## Analytical investigation and monitoring of end-zone reinforcement of the Alaskan Way viaduct super girders

"Comparison of Details for Controlling End-Region Cracks in Pretensioned Concrete I-Girders" by B. E. Ross, M. D. Willis, H. R. Hamilton, and G. R. Consolazio and "Analytical Investigation and Monitoring of End-Zone Reinforcement of the Alaskan Way Viaduct Super Girders" by A. Arab, S. S. Badie, M. T. Manzari, B. Khaleghi, S. J. Seguirant, and D. Chapman are collectively an important addition to the knowledge of end-zone cracking.[1,2] The photos of the crack patterns are not greatly different from those shown in Gamble[3] for a girder produced in 1966, though the recent photos show more cracks because the members are larger and much more heavily stressed. At that time, the extent of end-zone cracking did not seem to be widely appreciated or understood, even though this was slightly after publication of the important papers by Gergely et al. that are referenced in the two *PCI Journal* papers.[4,5]

Figure 1. Illinois 48 in. pretensioned girder. Note: F_{si} = design pretentsion force before transfer. Grade 250 = 1720 MPa; Grade 270 = 1860 MPa; 1 in. = 25.4 mm.

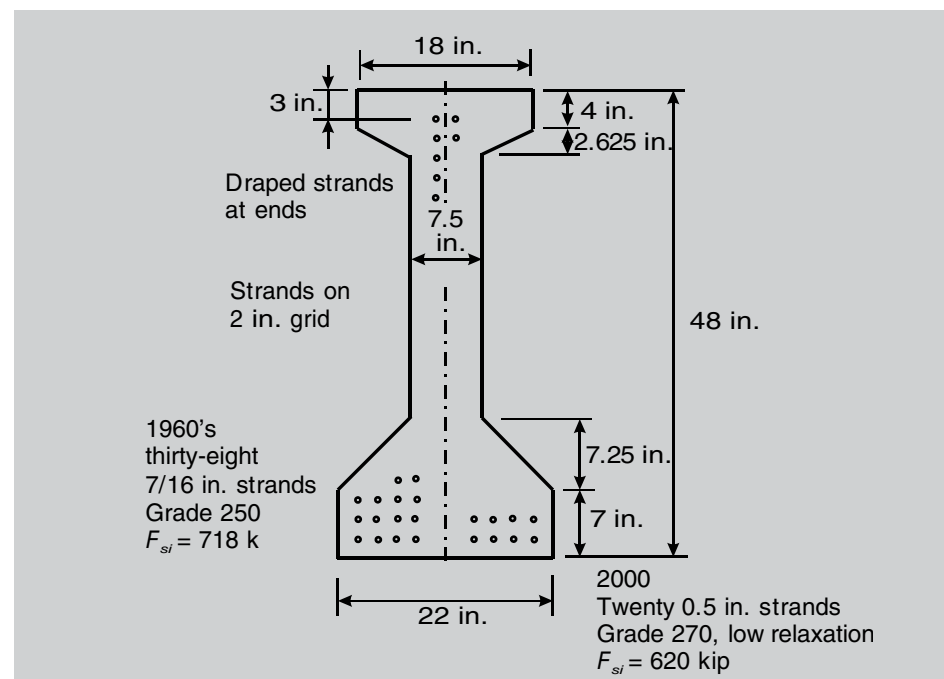
Both *PCI Journal* papers reference the AASHTO LRFD anchorage zone reinforcement requirement of 4% of the prestressing force,[6] to be resisted by deformed bars at 20 ksi (140 MPa). I find the retention of this value, which is carried over from earlier AASHTO specifications, to be puzzling because it recognizes neither the cross section shape nor the strand arrangement. The provision is also slightly ambiguous in that it does not state whether the prestressing force before or after transfer is to be considered. I have used the pretransfer value because it is slightly more conservative.

The cross section shown in Fig. 1 can be used to illustrate the problems with the 4% rule. The left side of the drawing shows the 1960s steel arrangement used for a beam with a span of about 72 ft (22 m) and a beam spacing of 8 ft (2.4 m). The right side shows the equivalent steel arrangement from the year 2000. The larger, stronger strands lead to a significantly greater eccentricity and, thus, to a smaller initial pretensioning force. The low-relaxation material also contributes to the reduction. The forces noted as F_{si} are the design pretensioning force, before transfer. On the basis of the 4% rule, the new design requires less end-zone reinforcement.

Figure 2. Results of Gergely analysis of girders.

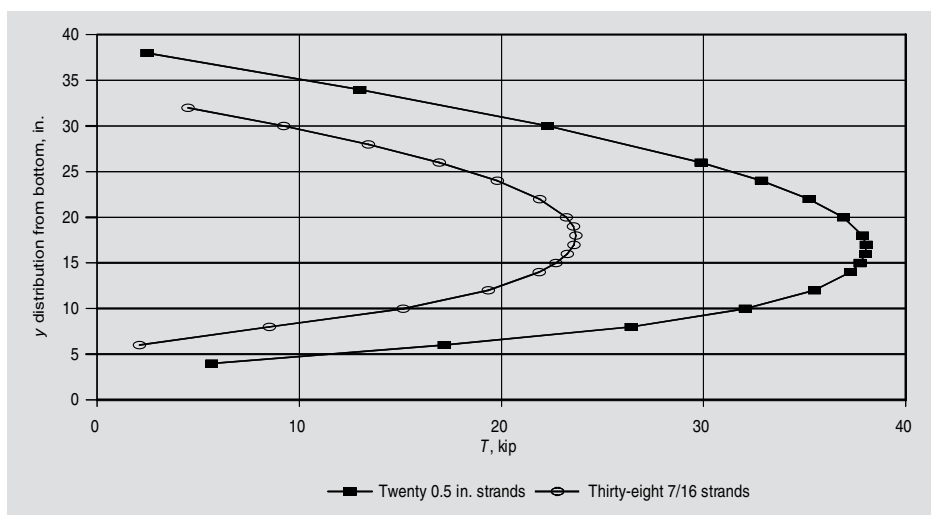
However, a Gergely-type analysis gives a quite different outcome. **Figure 2** shows the results of Gergely analyses for the two different cases. The case with twenty 0.5 in. (13 mm) strands has a tension force that is much larger than the earlier design and much larger than the 4% rule requires. Four percent of 620 kip (2800 kN) is 24.8 kip (110 kN), while the Gergely analysis gives a force of 38 kip (125 kN). The 4% rule is safe for the earlier case because 4% of 718 kip (3190 kN) is 28.7 kip (128 kN), while the Gergely analysis gives a maximum force of 23.7 kip (105 kN). A Gergely-type analysis is not too difficult, but it does require many details of the cross sections, including the area, moment of inertia, centroid, and the detailed variation in width of the section in the lower part of the member. The FIB-63 member is a bit messy in this respect, while the Alaskan Way super girders are fairly straightforward. While the Gergely analysis is mentioned in both papers, it is not clear whether it was actually used. The results might have been instructive.

Finally, during the instrumentation of the WF100G girders for the Alaskan Way Viaduct project, the authors used the Gergely-Sozen procedure[7] to determine the elevation where the splitting cracks were anticipated to initiate. The authors believe that although this procedure is simple and can be implemented using hand calculations, it does not accurately reflect the postcracking behavior of reinforced concrete sections. In addition, the amount of the end-zone reinforcement determined by this method is significantly influenced by certain assumptions such as the distance between the tension and compression resultants corresponding to the coupling action imposed by the moment within the end zone.
